No.	Date	Description
1	2025-09-19	Add No. 1
2	2025-09-30	Add No. 2

**WCFPD Station 3**  
**Wright City Fire Protection District**  
9 Highway WW  
Wright City, MO 63390

1 WALL SECTION 1/A321  
A321 3/4" = 1'-0"

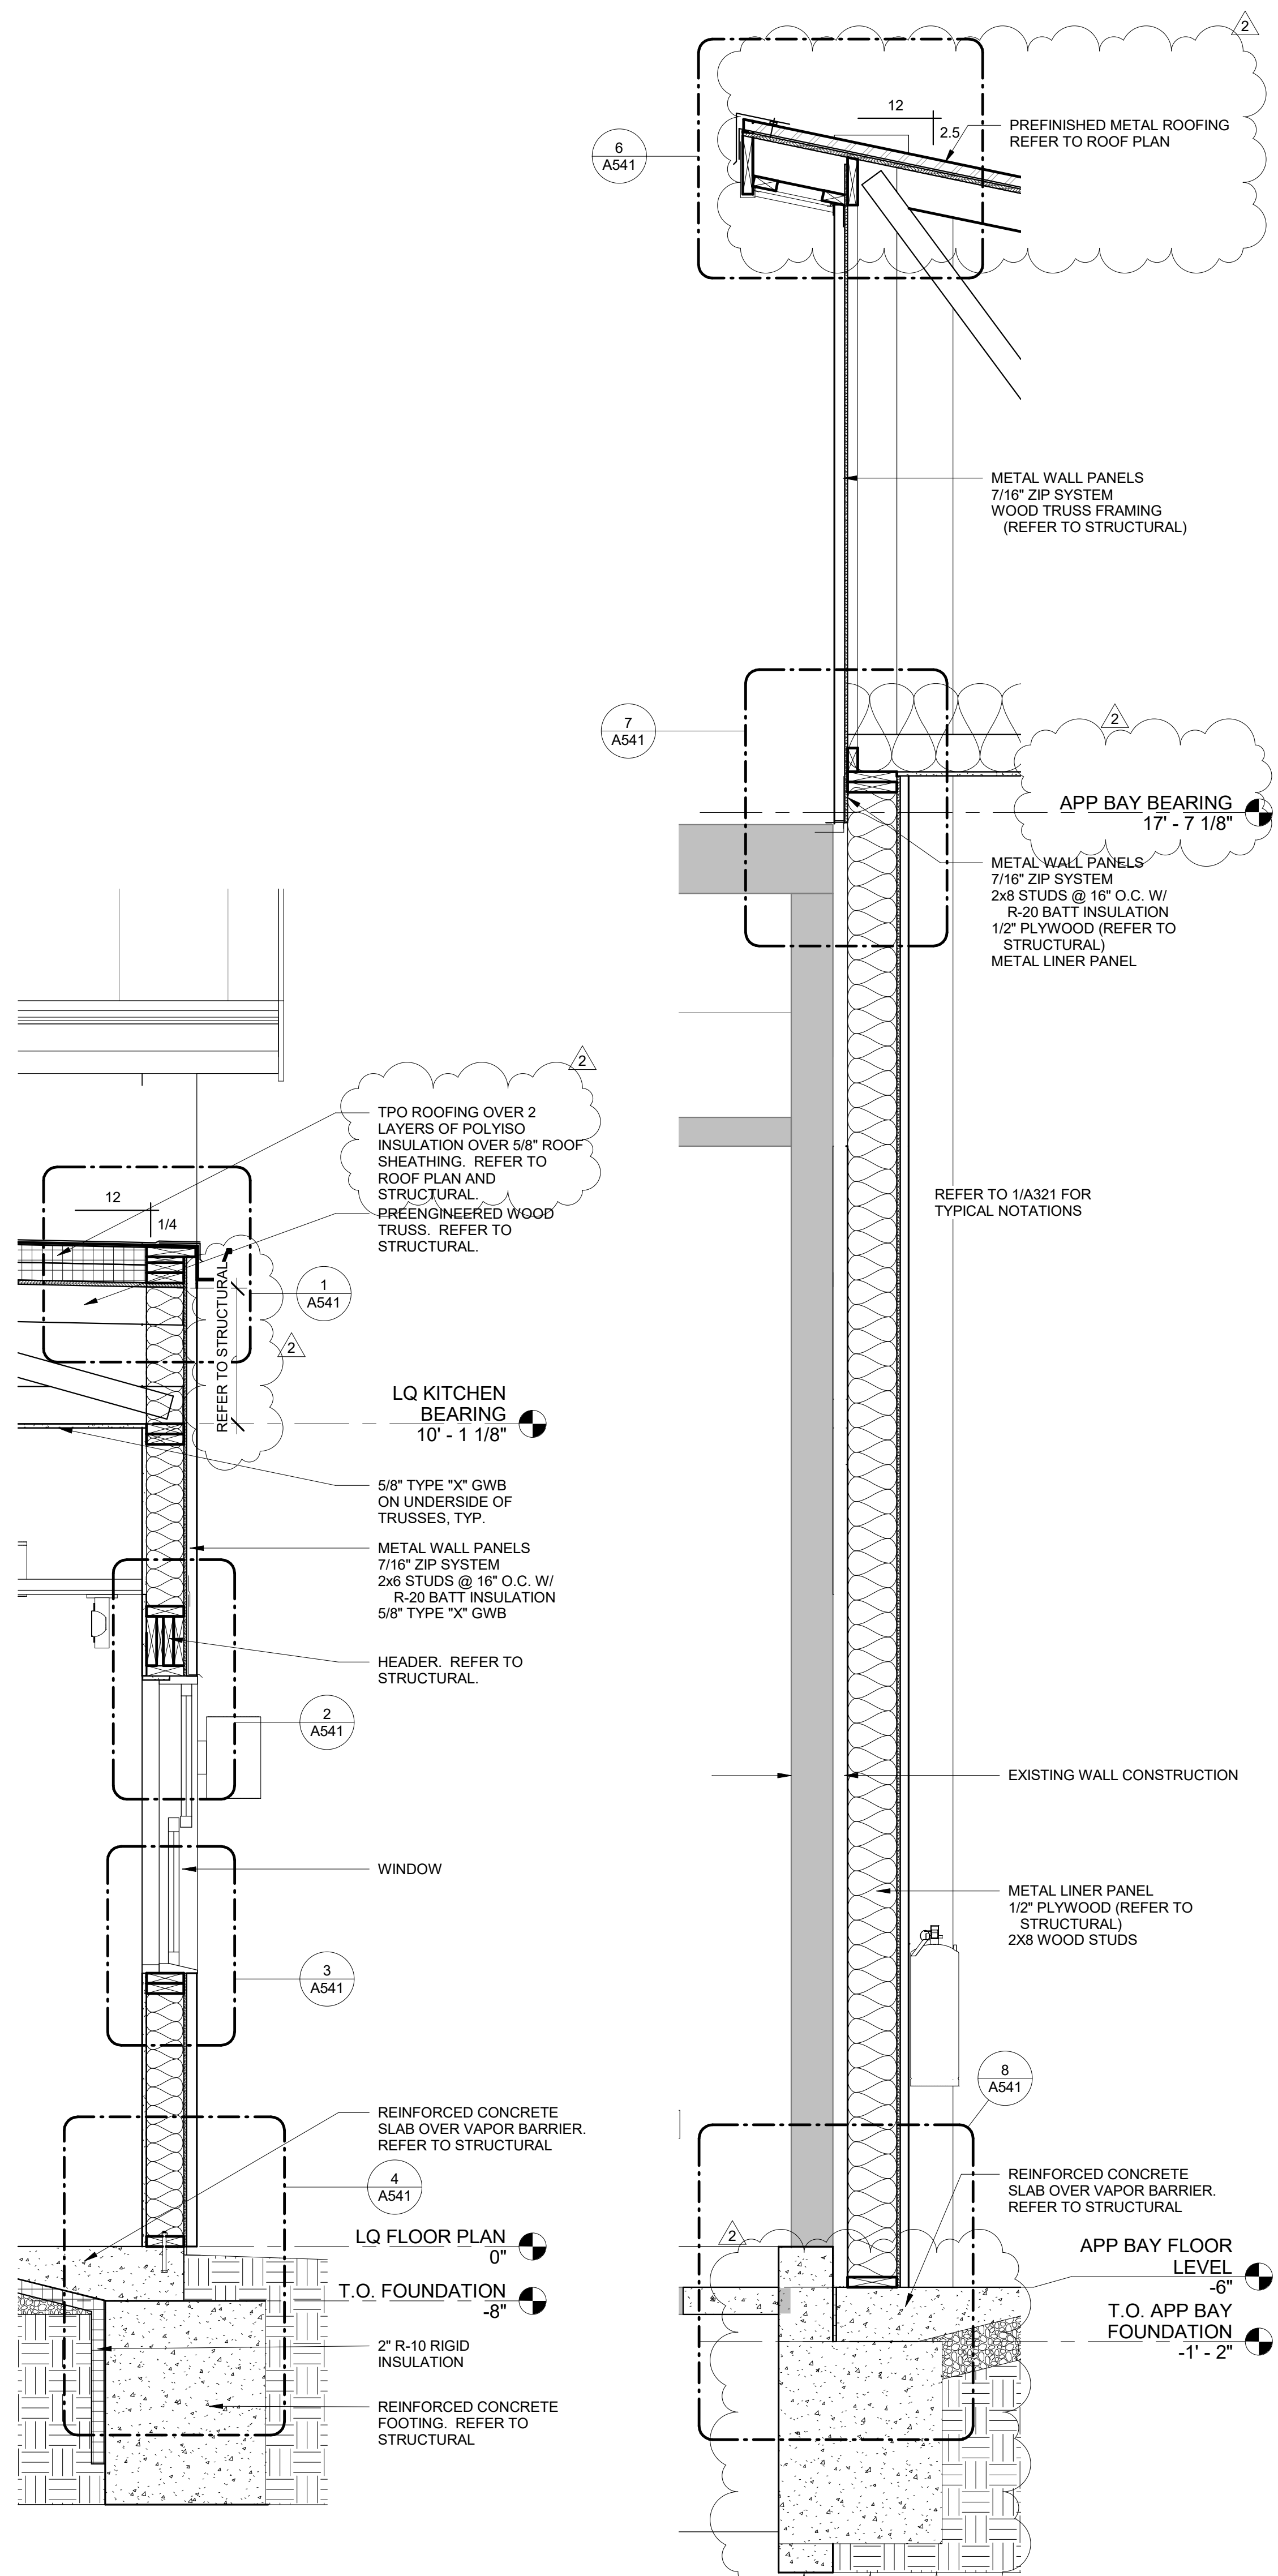
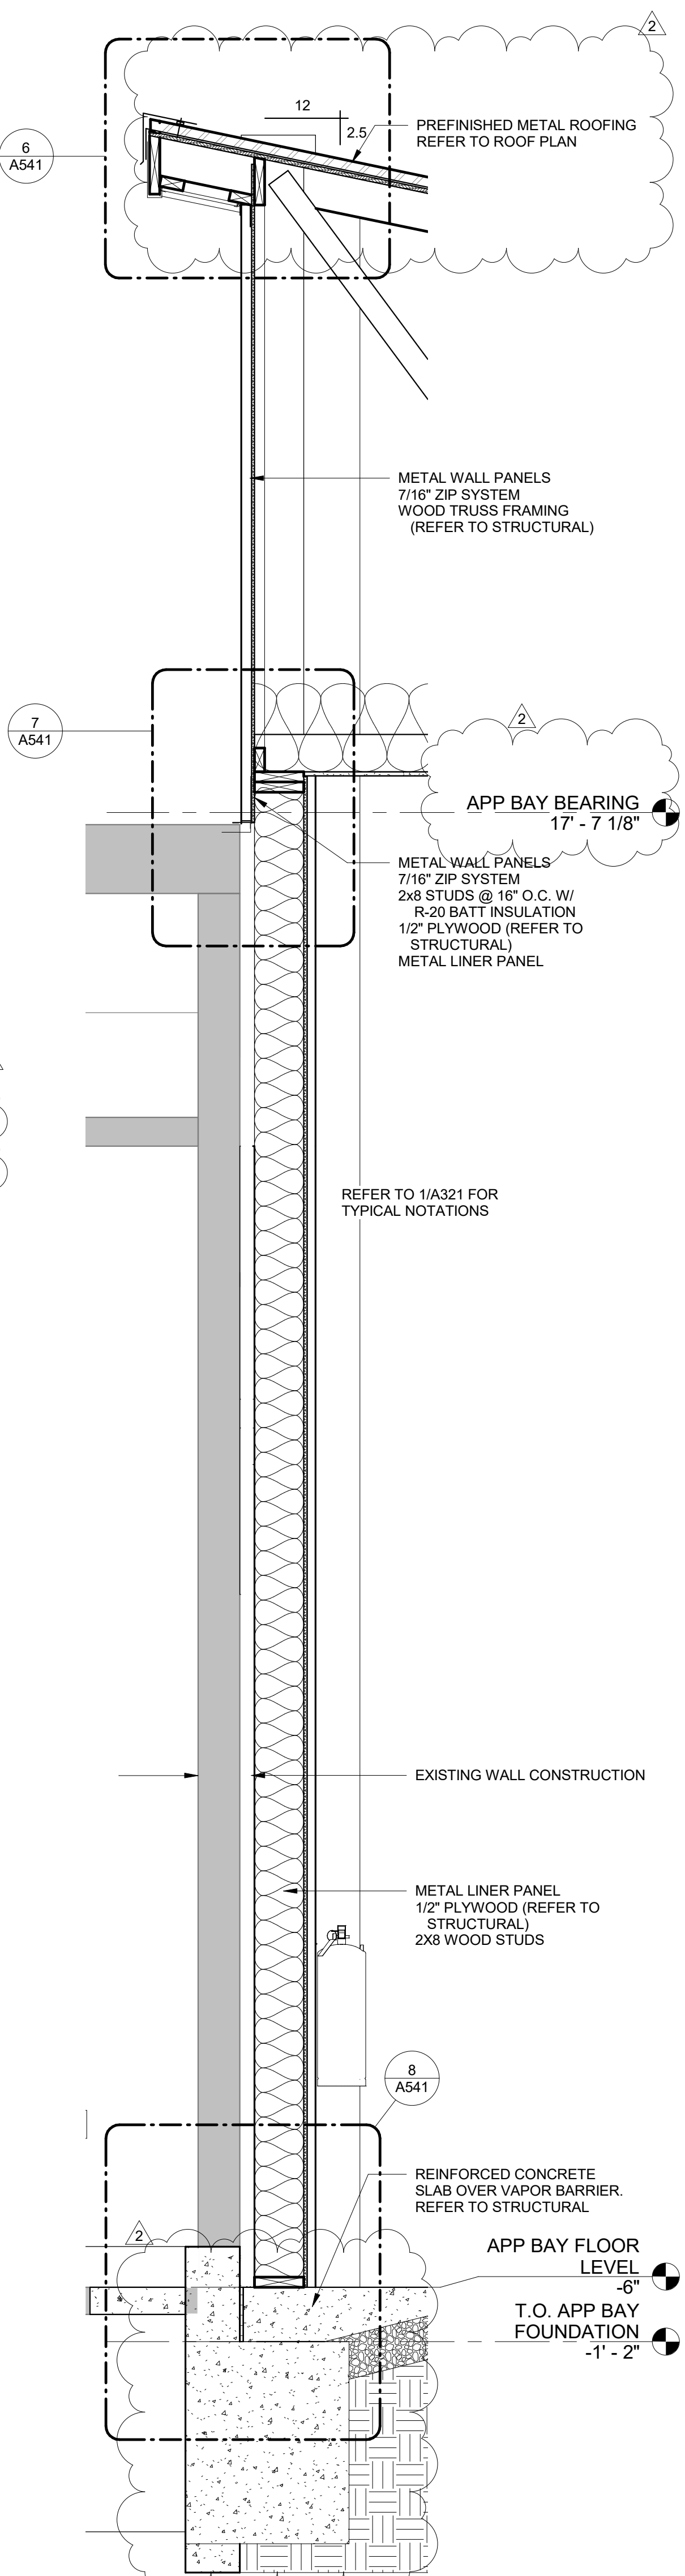
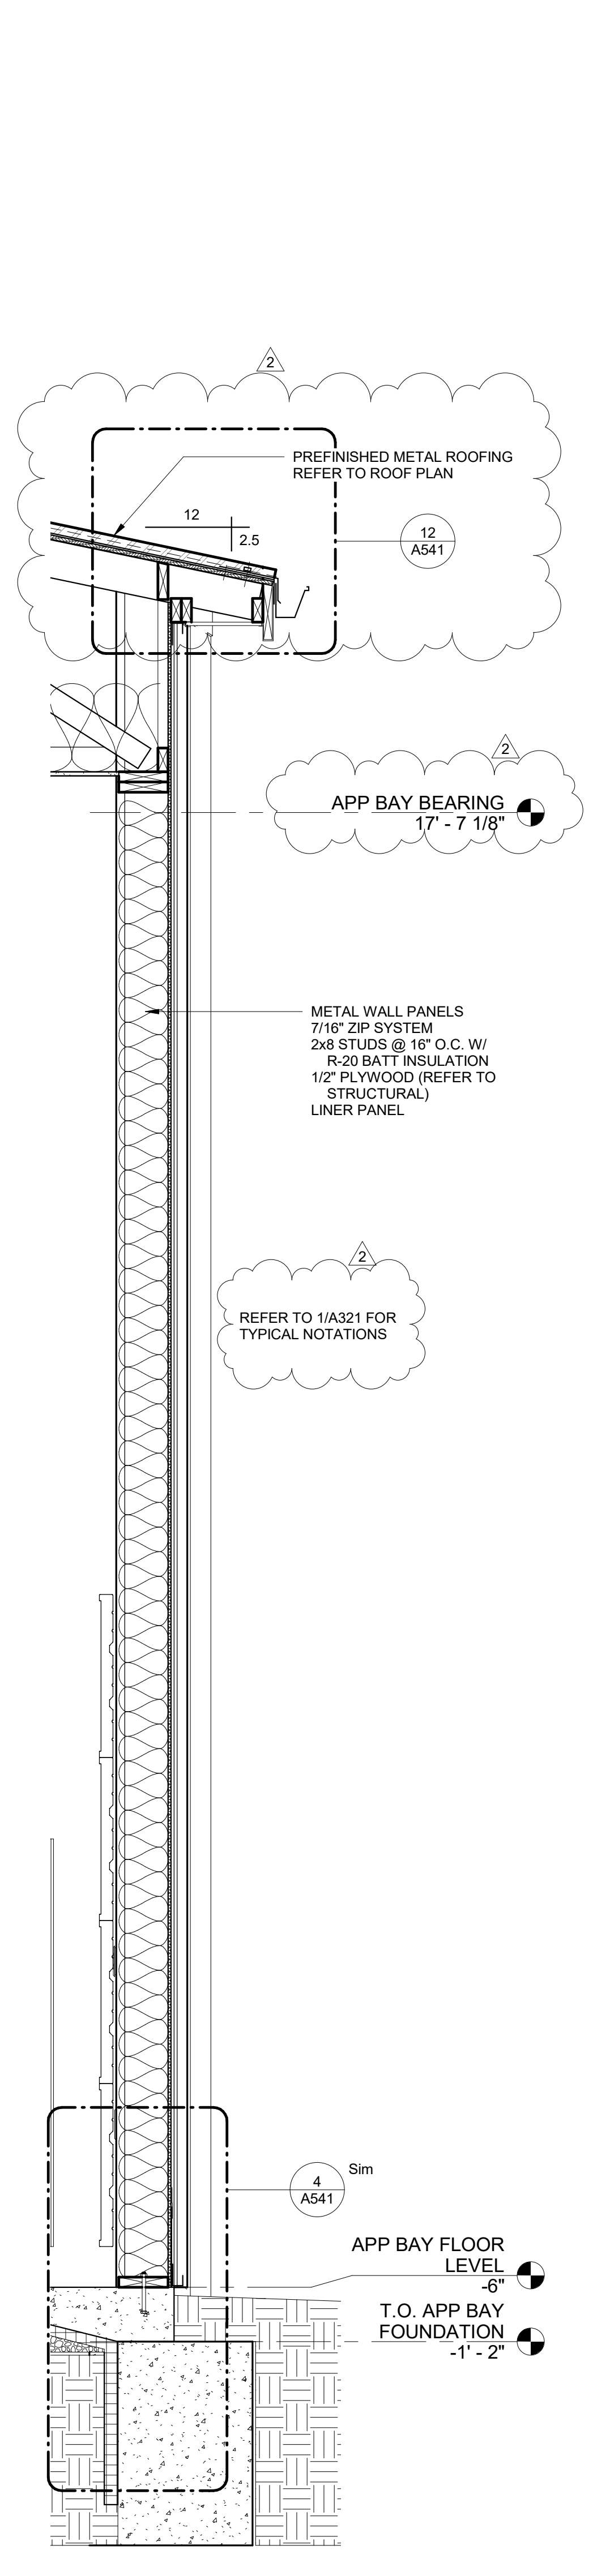
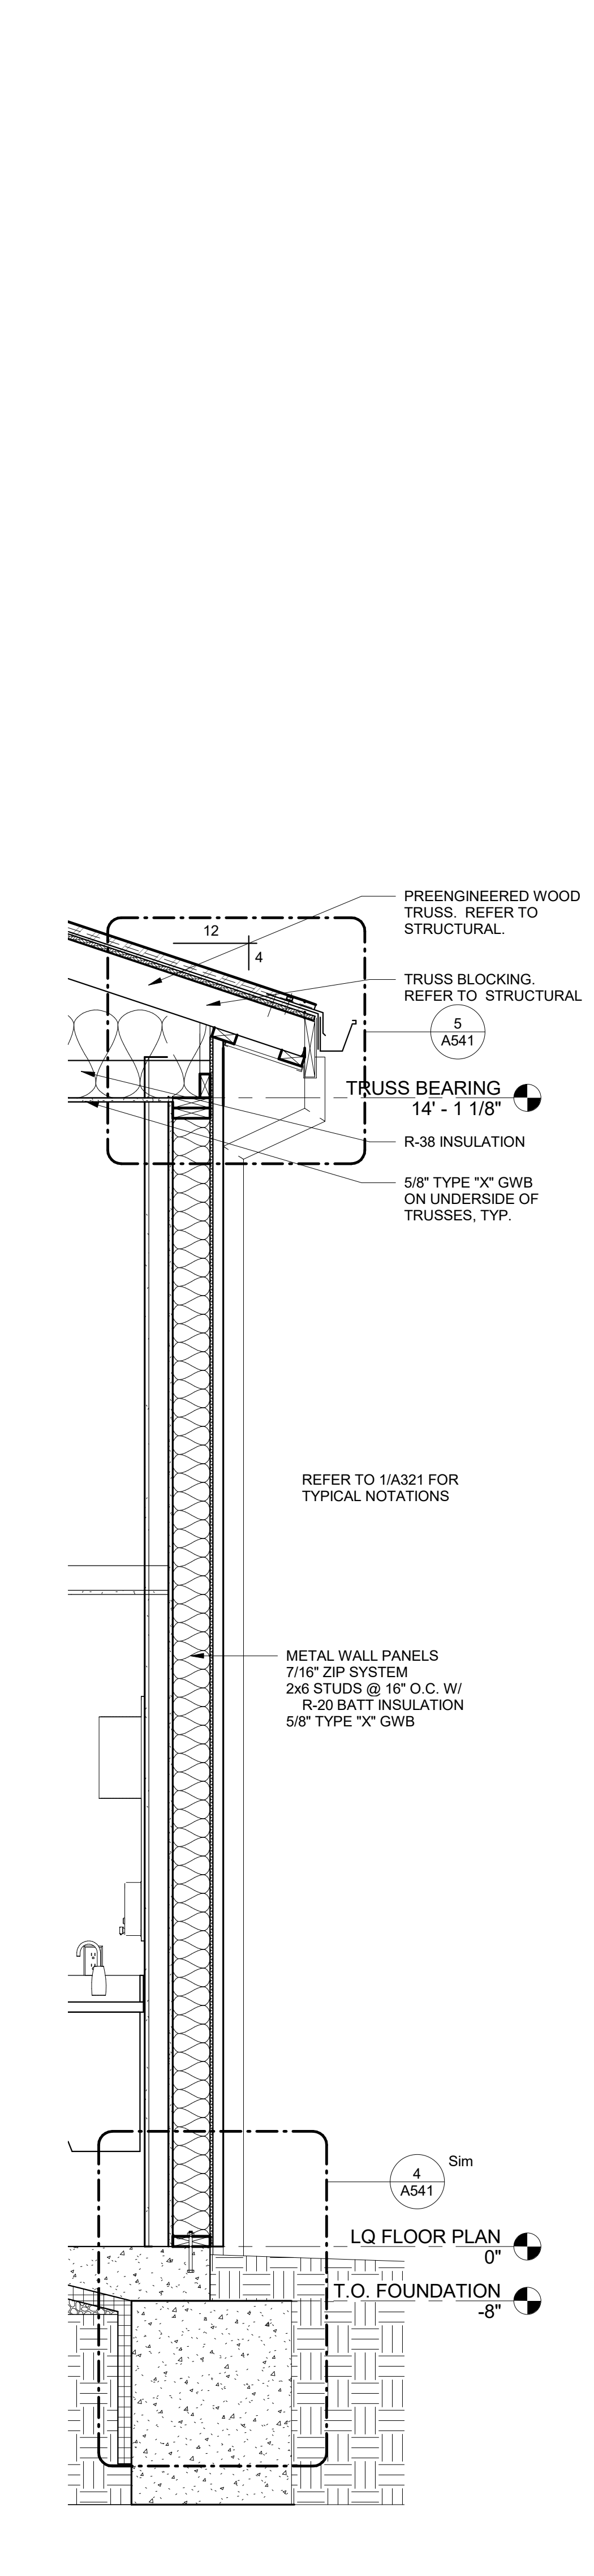
- 23) Sheet A321 – WALL SECTIONS
  - a. REVISE all wall sections.
  - b. ADD fireblocking note.
- 24) Sheet A322 – WALL SECTIONS
  - a. REVISE wall sections.
